Service Bulletin

REFRIGERATORS

ALL SIDE-BY-SIDE GSS25, GSF25, GSH25

REF 04-08

Fig 1

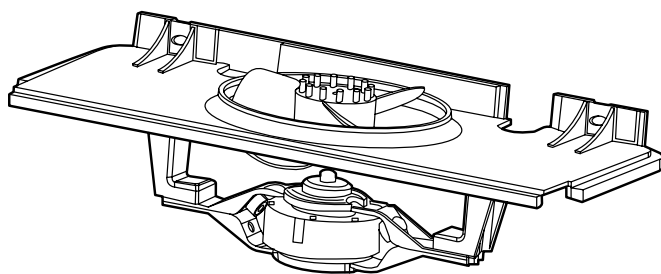
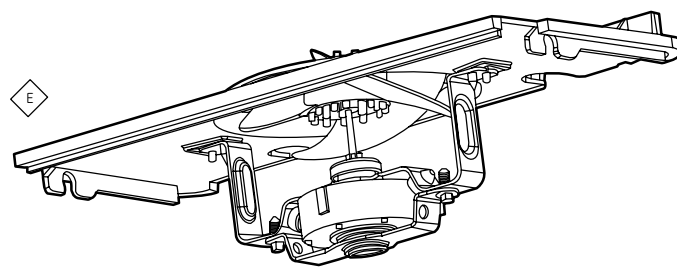
EVAPORATOR FAN NOISY, BLADE HITTING ORIFICE-MISALIGNED, EVAPORATOR FAN NORMAL NOISE

You may find an ORIFICE FAN ASSEMBLY (Fig. 1) instead of the Orifice Fan referenced in IPC (Fig. 2), this change is made to address a noise issue.

Install "ORIFICE FAN ASSEMBLY KIT", **WR49X10190**. This will alleviate the evaporator fan noise.
